Form 3160-5
(June 2019)UNITED STATES
DEPARTMENT OF THE INTERIOR
BUREAU OF LAND MANAGEMENTFORM APPROVED
OMB No. 1004-0137
Expires: October 31, 2021**SUNDRY NOTICES AND REPORTS ON WELLS**
Do not use this form for proposals to drill or to re-enter an abandoned well. Use Form 3160-3 (APD) for such proposals.

8. Well Name and No. JAMES RANCH UNIT DI 8 EAGLE/1

**Pool Change, SHL Change, Spacing, Casing/Cement, Drilling Variance Changes

XTO Permian Operating, LLC requests permission to make the following changes to the original APD:

WELL LOCATION AND ACREAGE DEDICATION PLAT

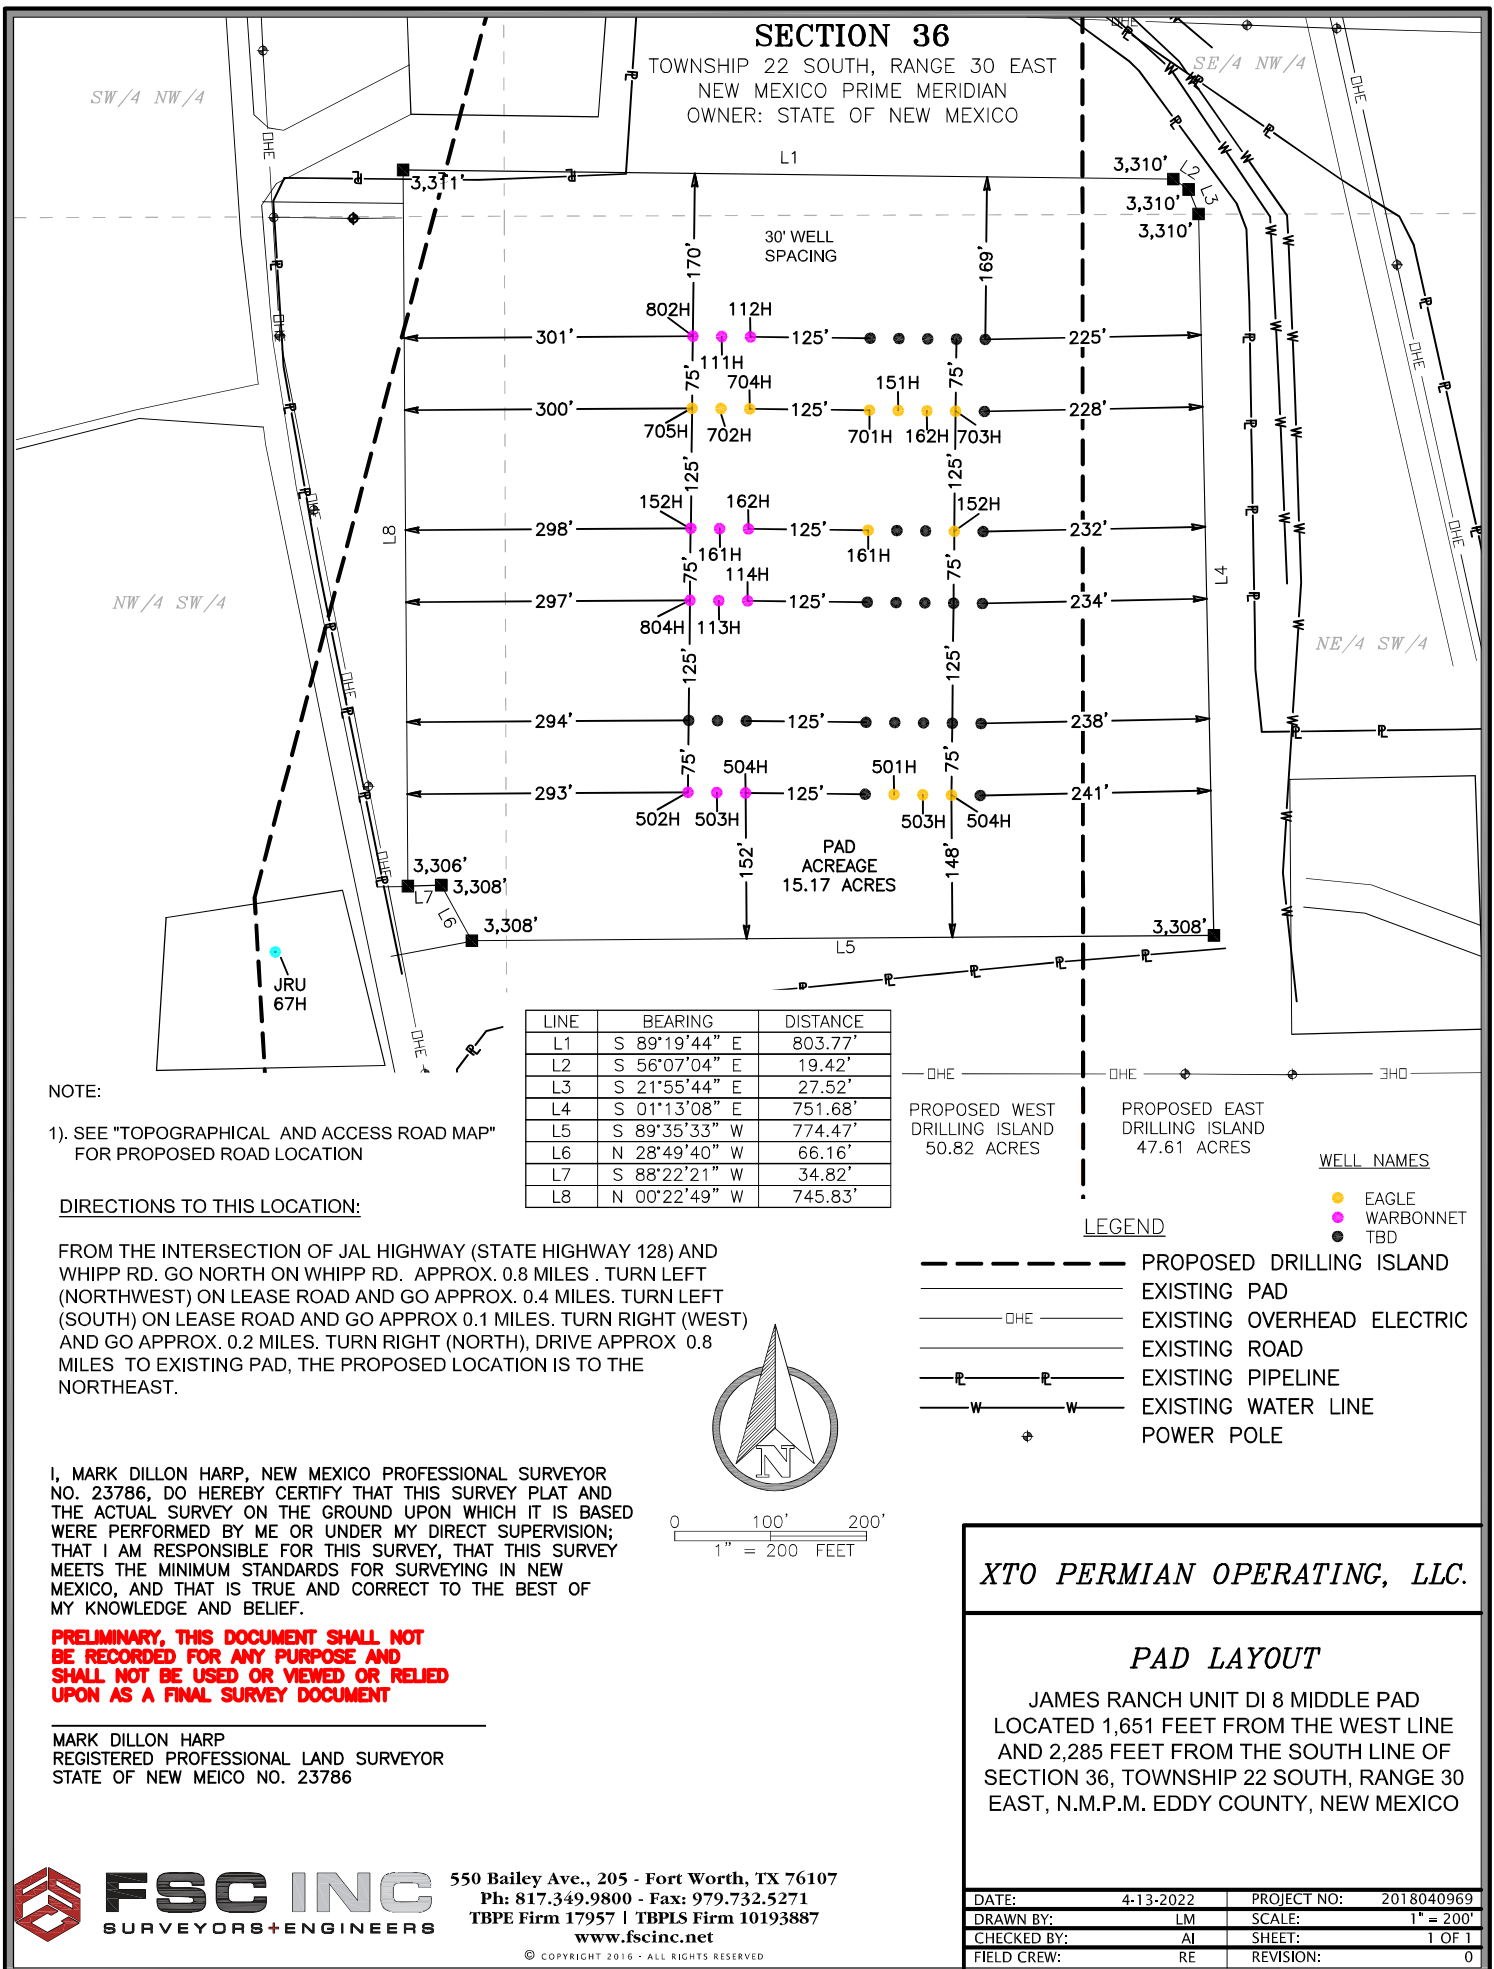
Change SHL fr/2311FSL & 1746FWL to 2436FSL & 1777FWL

Total SHL Move: 125 North & 31 West

Change BHL fr/1650FNL & 50FEL to 1950FSL & 50FEL
Casing/Cement design per the attached drilling program.
